MODEL
2014~2016MY
Cadenza (VG)

NUMBER
148 (Rev 1, 03/01/2016)

TECHNICAL SERVICE BULLETIN

SUBJECT: CHATTER/RATTLE NOISE FROM ENGINE AFTER COLD SOAK

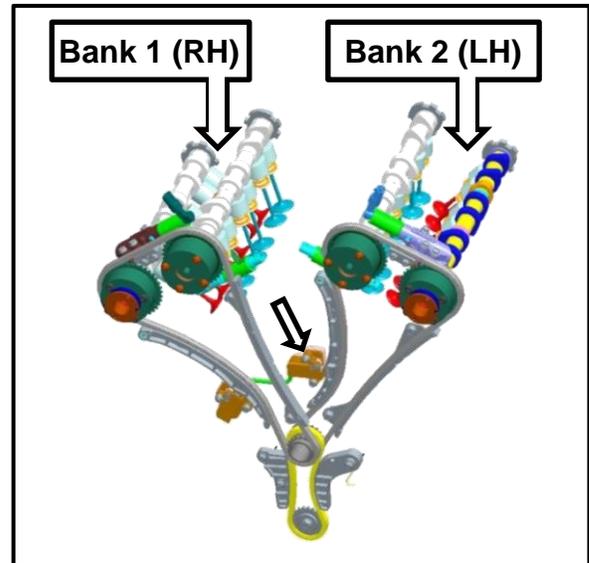
This Service procedure should ONLY be performed on engine bank 2 (LH), as shown.

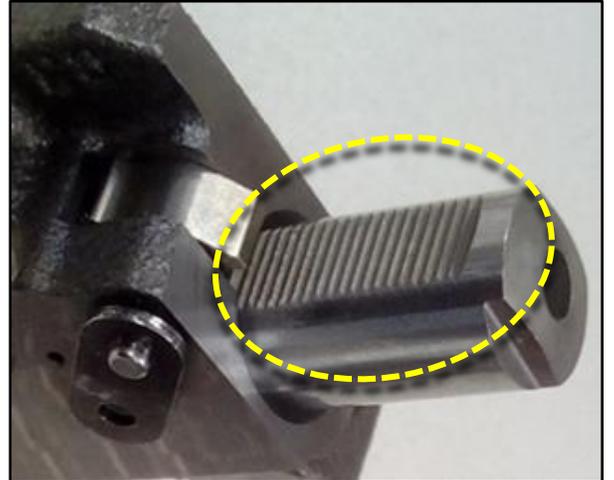
New tensioner design with finer pitch on teeth (1.5mm)

1. Refer to the “Engine Mechanical System → Timing System → Timing Chain” section in the applicable Workshop Manual on KGIS, to install the improved part.
2. Once proper tensioner installation has been completed, re-install all removed components by reversing the order of removal.
3. After confirming proper engine oil and coolant levels, start the engine and verify the rattle concern has been resolved.
